R. E. GINNA NUCLEAR POWER PLANT

AMENDMENT TO FACILITY OPERATING LICENSE

Amendment No. 16
License No. DPR-18

SAFETY EVALUATION BY THE OFFICE OF NUCLEAR REACTOR REGULATION
SUPPORTING AMENDMENT NO. 16 TO FACILITY OPERATING LICENSE NO. DPR-18

FIGURE 6.2-1

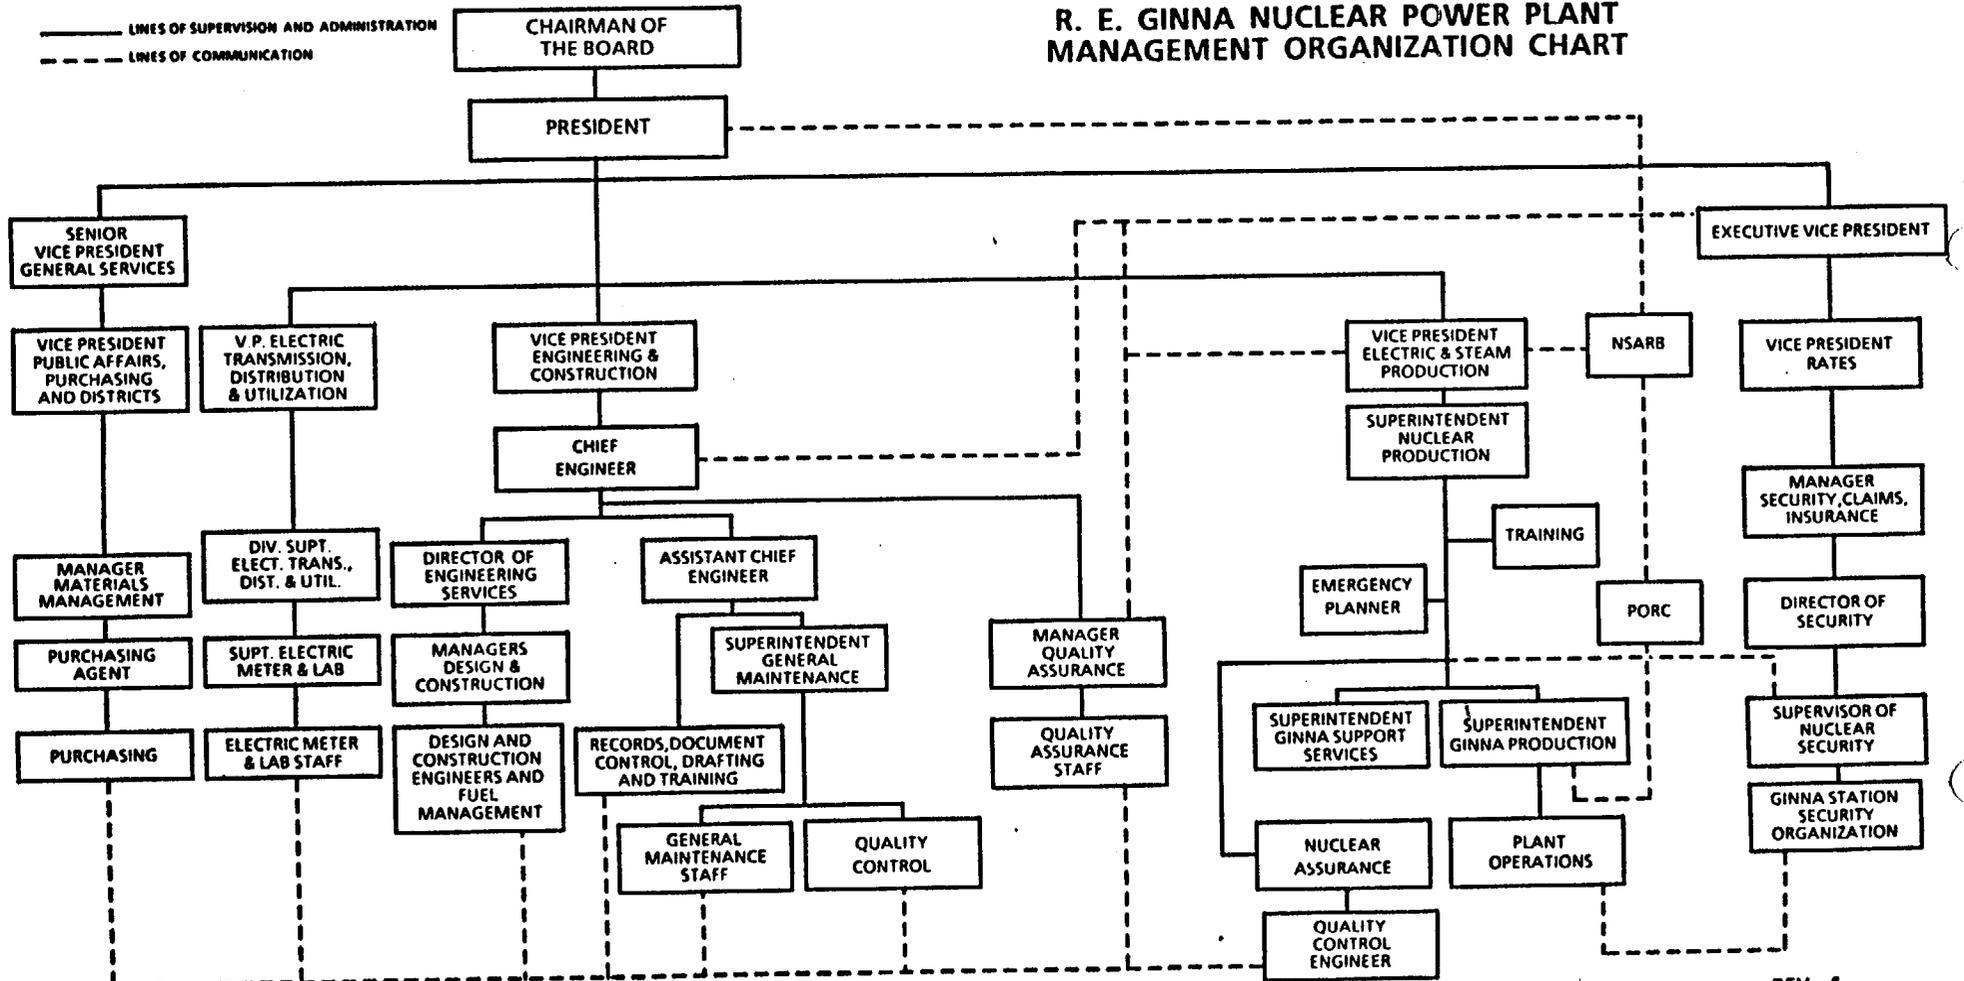
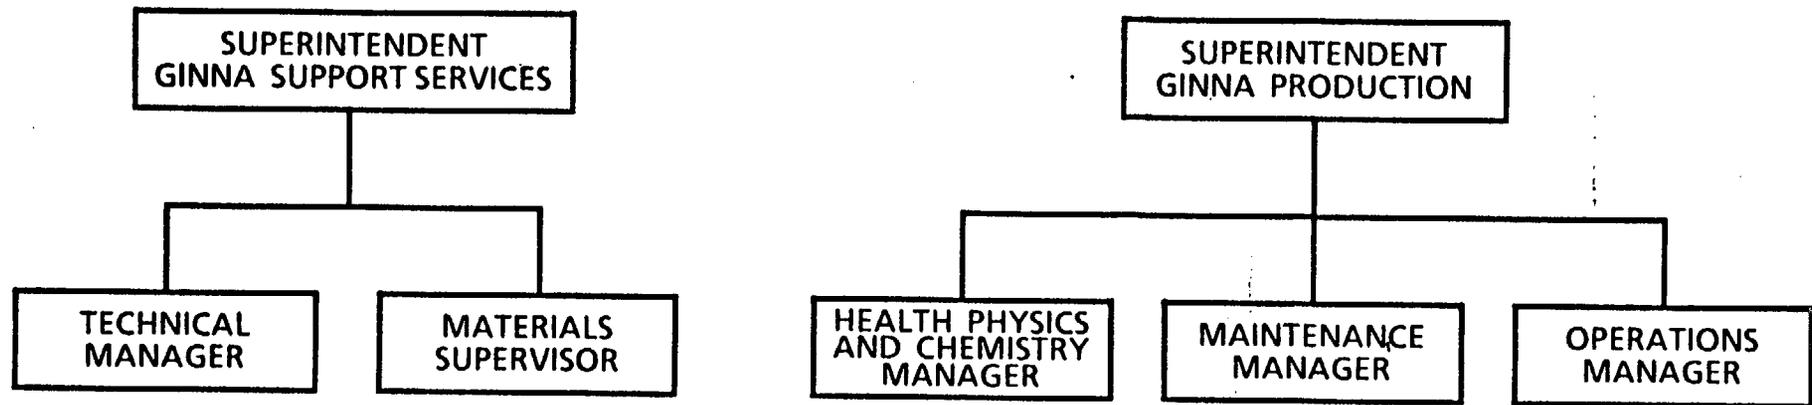
There are other changes in the plant organization. The Superintendent, Nuclear Production, the equivalent to a plant manager's position, now reports directly to the Vice President, Electric and Steam Production. Two new positions have been created, that of Superintendent-Ginna Production and Superintendent-Ginna Support Services, who report to the Superintendent, Nuclear Production. The new Plant Operations organization reports directly to the Superintendent-Ginna Production. The position of Assistant Superintendent has been eliminated. The Health Physics and Chemistry Manager, the Maintenance Manager, and the Operation Manager will report to the Superintendent-Ginna Production. The Technical Manager and the Materials Supervisor will report to the Superintendent-Ginna Support Services. We conclude that these changes will make the day-to-day operation of the station more effective by creating a group to concentrate on operations, maintenance and health physics and chemistry and are therefore acceptable.
